ENGINE - DEDICATED ALTERNATOR ROTOR - INTRODUCTION OF NEW SOURCE OF SUPPLY - CATEGORY
CODE 7 - MOD.ENG-72-0229

V2500-ENG-72-0229

SERVICE BULLETIN

LOCATION OF DEDICATED ALTERNATOR ROTOR
Fig.1

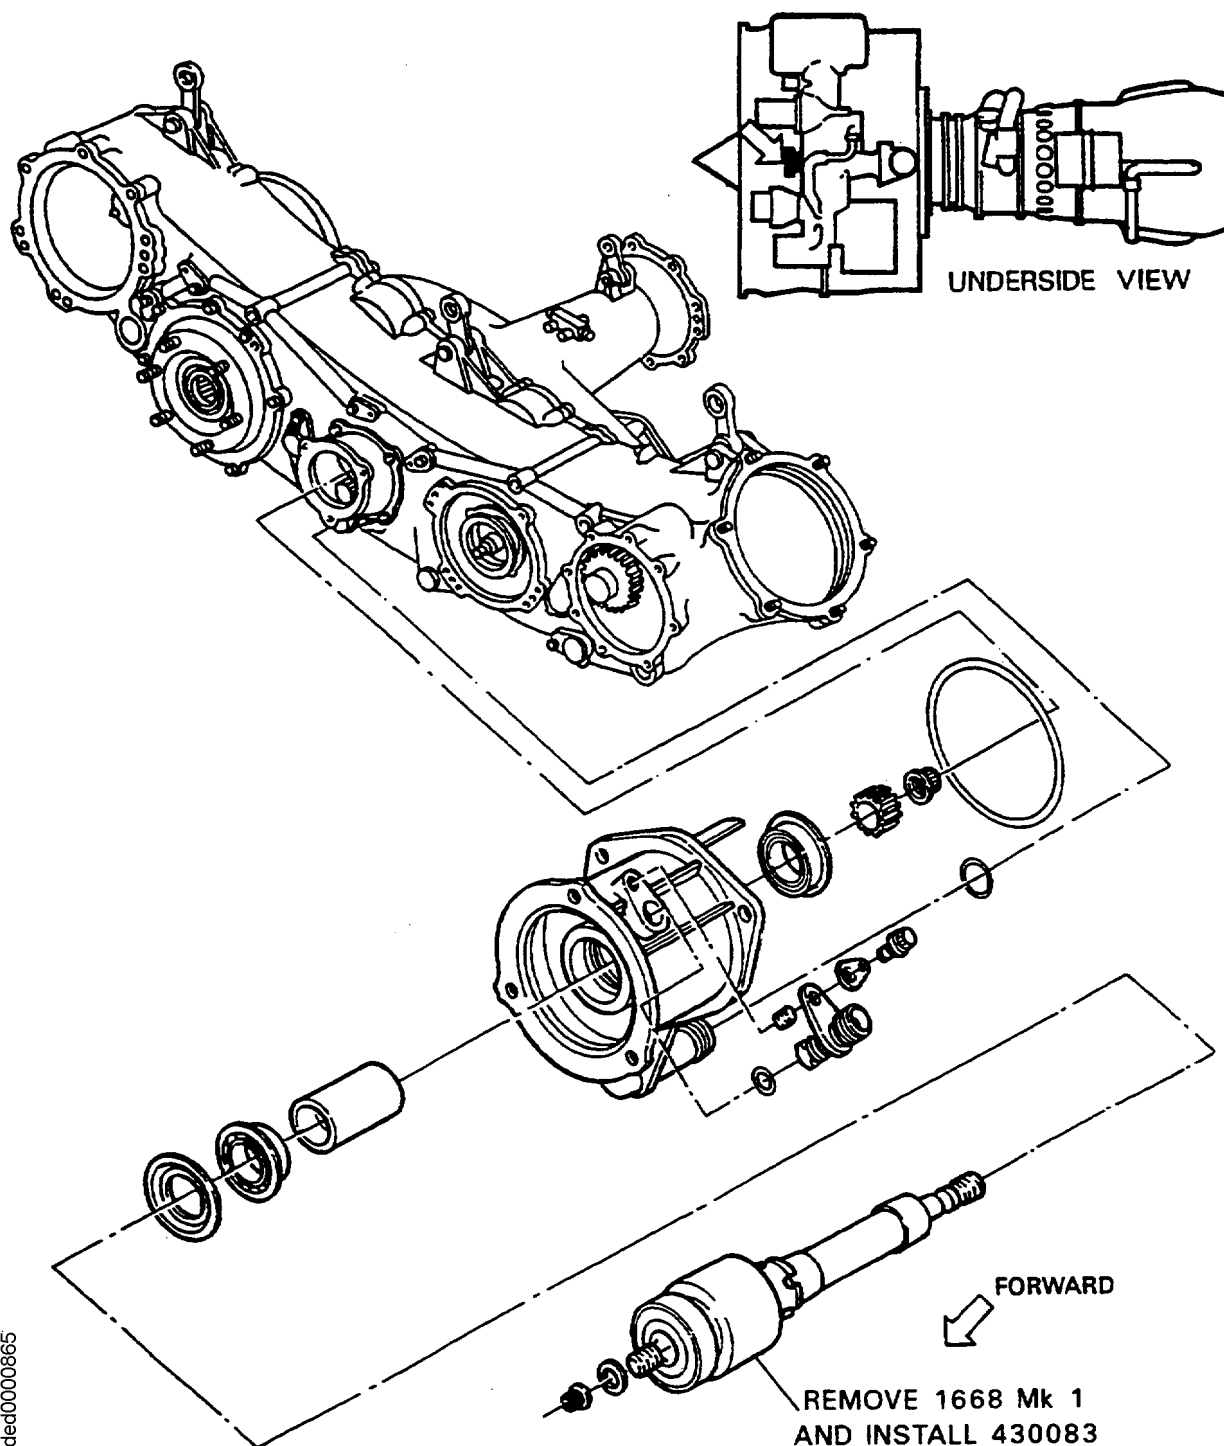
Incorporation of this Service Bulletin is designed to introduce a new source of supply for the Engine Dedicated Alternator Rotor.

B.F. Goodrich (B.F.G.) has been chosen as the new unit supplier. The B.F.G. rotor introduced by this Service Bulletin is completely interchangeable with the current rotor. The new unit has completed rig and bench tests successfully.

- (1) This Bulletin covers the introduction of a new Engine Dedicated Alternator Rotor supplied by B.F. Goodrich.
- (2) Units introduced by this Bulletin will be identified by the type number 430083.

- (1) Install the new 430083 Dedicated Alternator Rotor as instructed in Reference (1) TASK 72-60-10-440-001, SUBTASK 72-60-10-440-066.
